SUBJECT: ST. LUCIE PLANT UNITS 1 AND 2– STAFF ASSESSMENT OF RESPONSE TO
10 CFR 50.54(f) INFORMATION REQUEST – FLOOD-CAUSING MECHANISM
REEVALUATION (CAC NOS. MF6113 AND MF6114)

STAFF ASSESSMENT BY THE OFFICE OF NUCLEAR REACTOR REGULATION

RELATED TO FLOODING HAZARD REEVALUATION REPORT

ST. LUCIE NUCLEAR POWER PLANT, UNITS 1 AND 2

Figure 3.2-1: LIP Points of Interest at the St. Lucie Site (Source FPL, 2015a)

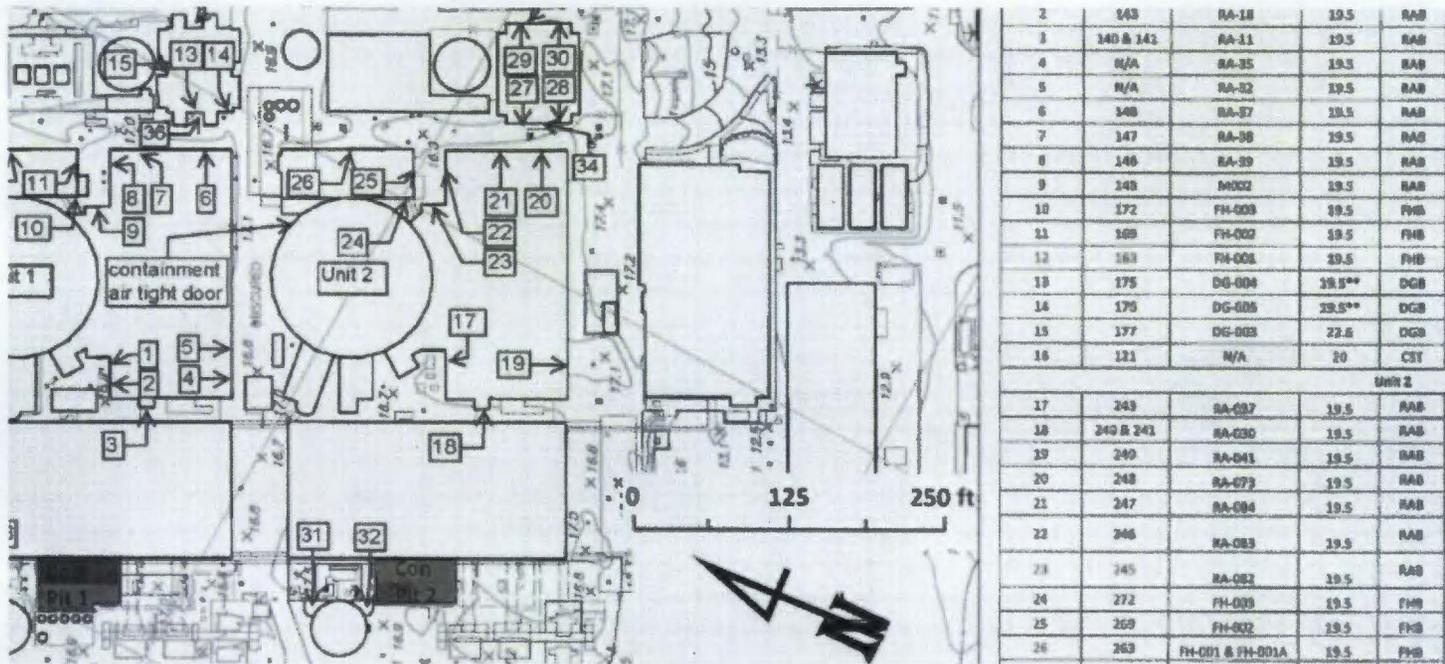
The licensee reported reevaluated flood elevations at 36 points of interest (POIs) within the powerblock and at the intake structure location in response to a 1-h, 1-mi² PMP event (FPL, 2015a). The locations of these POIs are shown in Figure 3.2-1. The licensee obtained flood

elevation time series and depth for each of the POIs. Six LIP scenarios were simulated for 2-h simulation time to obtain flood elevations, as well as periods of inundation and recession. Table 3.2-1 of this assessment shows the maximum WSEs and flood depths at each of the POIs, that is, peak values among six scenarios. POIs 1 through 16 represent locations near St. Lucie, Unit 1 and POIs 17 through 36 represent locations near the St. Lucie, Unit 2. The maximum flood depths ranged from 0.1 ft to 3.2 ft. The maximum depth at St. Lucie, Unit 1 is 3.2 ft. and was the result of Scenario A (both units operating without the addition of the FLEX building). The maximum depth at St. Lucie, Unit 2 is 2.1 ft and was the result of Scenario F (no units operating with the addition of the FLEX building).

The licensee reported the maximum mass balance error for the LIP simulations was 2×10^{-6} percent (FPL, 2015a). The NRC staff reviewed the licensee's input and output files and observed that the mass balance error for the FLO-2D model ranged from 1.4×10^{-5} to 1.6×10^{-5} acre-ft. This range was within the maximum mass balance error reported by the licensee. The inundation areas and flow pathways appear reasonable, and the flow velocities are reasonable, with no indication of numerical instabilities and no supercritical flow conditions. Based on those results, the NRC staff concluded that the licensee's FLO-2D model has a reasonable basis for evaluating the potential flood hazard due to the LIP flood-causing mechanism.

In summary, the NRC staff confirmed the licensee's conclusion that the reevaluated flood hazard for LIP and associated site drainage is not bounded by the CDB flood hazard. Therefore, the NRC staff expects that the licensee will submit a focused evaluation for LIP and associated site drainage for the St. Lucie site.
